AMENDMENT UNDER 37 C.F.R. § 1.116  
U.S. Appln. No. 09/834,946

**REMARKS**

FIG. 1A

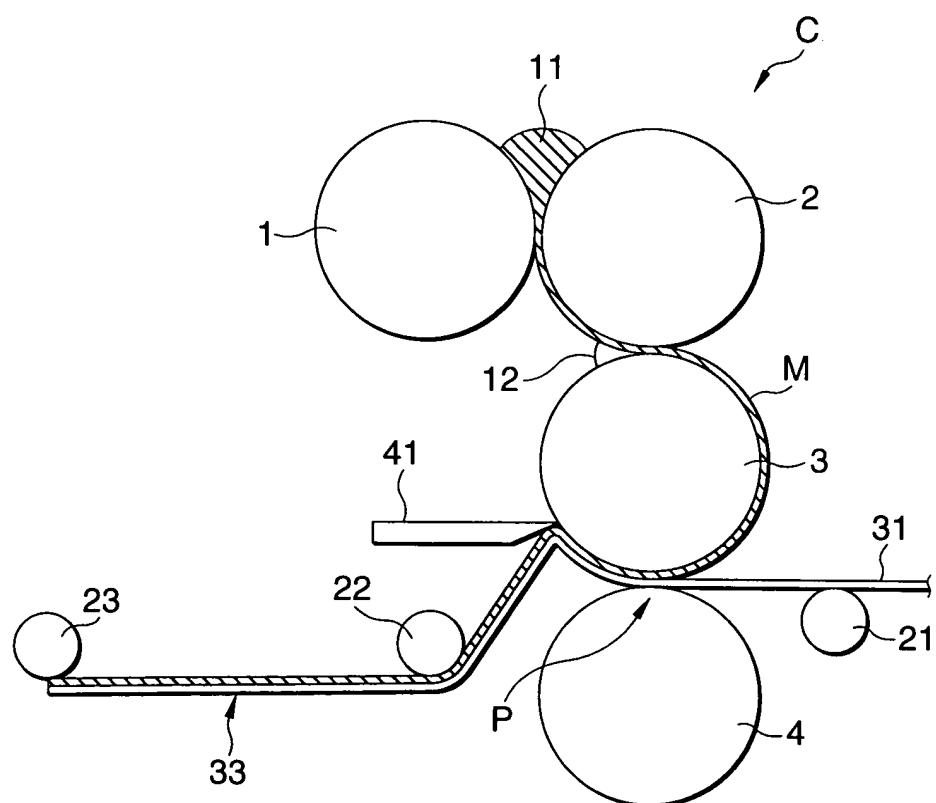
In the Office Action, the Examiner states that in "Line 11, the claim amended by adding the type of releasing the layer by curling it with the release member, the specification (from page 7 and thereafter, as mentioned in applicant's remarks) does not clearly show the specific type of curling process beside the releasing process. Further, it is inherent that the layer is curl/peel off the roll when the layer is being released by the release member."

Regarding the rejection to Claim 5 (the layer is curled/peeled off the roll), Applicants traverse the Examiner's rejection of Claim 5 by pointing to Fig. 1 which clearly shows that a plastic material sheet layer of said laminated sheet is released from said holding roller by curling it with said release member. Furthermore, Applicants submit that the curling process is deliberately created by the Applicants to support certain unexpected benefits in production such as a smoother tackiness surface without generating the projections and depressions on the surface of the pressure-sensitive adhesive.

In order to more clearly claim their invention, Applicants amend Claims 1 and 5 which more clearly establish distinctions over Masayuki et al. Claims 1 and 5 recite the description that a set of calender rollers comprises at least three rolling rollers and one feed roller, wherein a nip portion is formed with a pair of nip rollers including a holding roller for holding said rolled plastic material sheet, and behind said nip portion of a center roller, a release member for releasing a laminated plastic material sheet from the holding roller is arranged in proximity to or in contact with the holding roller, and the feed roller for providing a releasing force to the laminated plastic material sheet is arranged at the position lower than the position of the nip portion. Support for the rolling rollers is clear from Fig. 1, elements 1, 2, 3 and 4, in the

FIG. 1C

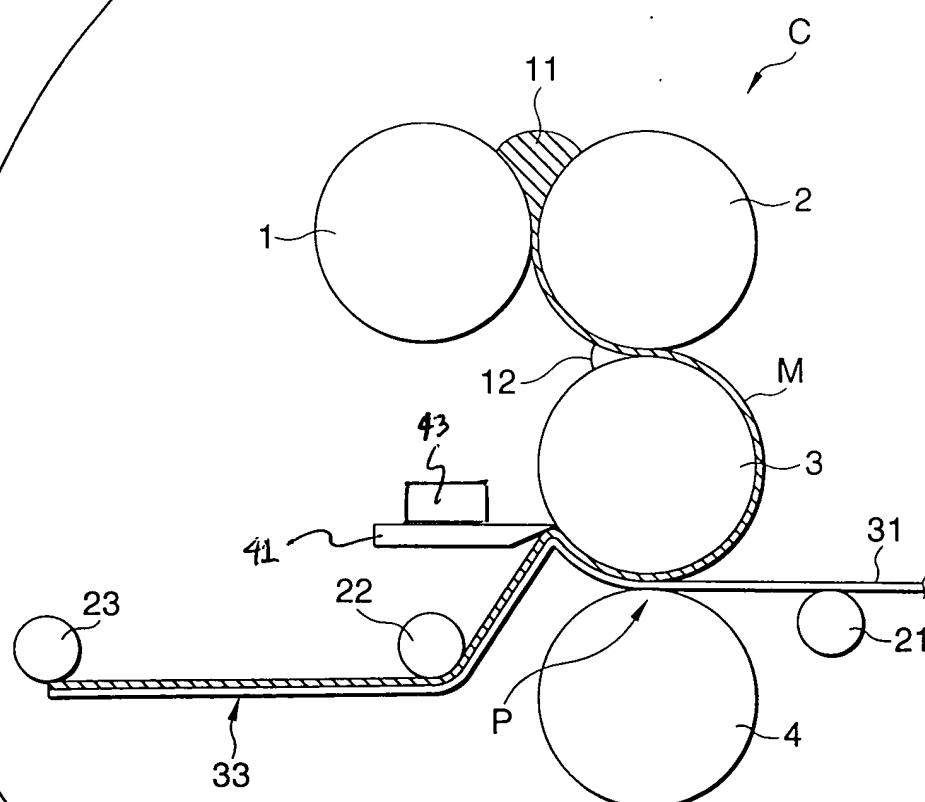
The Examiner has objected to the drawings under 37 CFR 1.83(a) because the drawings allegedly do not show every feature of the invention specified in the claims. The Examiner states that means for heating (Claim 2), means for vibrating (Claim 3), a band heater (Claim 11), and an air cylinder (Claim 12) must be shown or the feature(s) canceled from the claim(s).

Applicants submit a Request for Approval of Proposed Drawing Corrections concurrently herewith and provide corrected drawings showing the means for heating (a band heater) in Fig. 1B and the means for vibrating (an air cylinder) in Fig. 1C. The conventional features of a band heater and an air cylinder are illustrated in the drawings in the form of labeled rectangular boxes as their detailed illustrations are not essential for a proper understanding of the invention, in accordance with 37 C.F.R. § 1.83. Accordingly, Applicants respectfully request withdrawal of the objections to the drawings.

Fig. 1A is a view illustrating calendar rollers provided with a doctor knife disposed behind a nip portion of a center roller (holding roller) for holding a plastic material sheet. Fig. 1B illustrates a means for heating a release member with a band heater, indicated by reference number 42, attached to a doctor knife, indicated by reference number 41. Fig. 1C illustrates a means for vibrating a release member with an air cylinder, indicated by reference number 43, attached to a doctor knife, indicated by reference number 41.
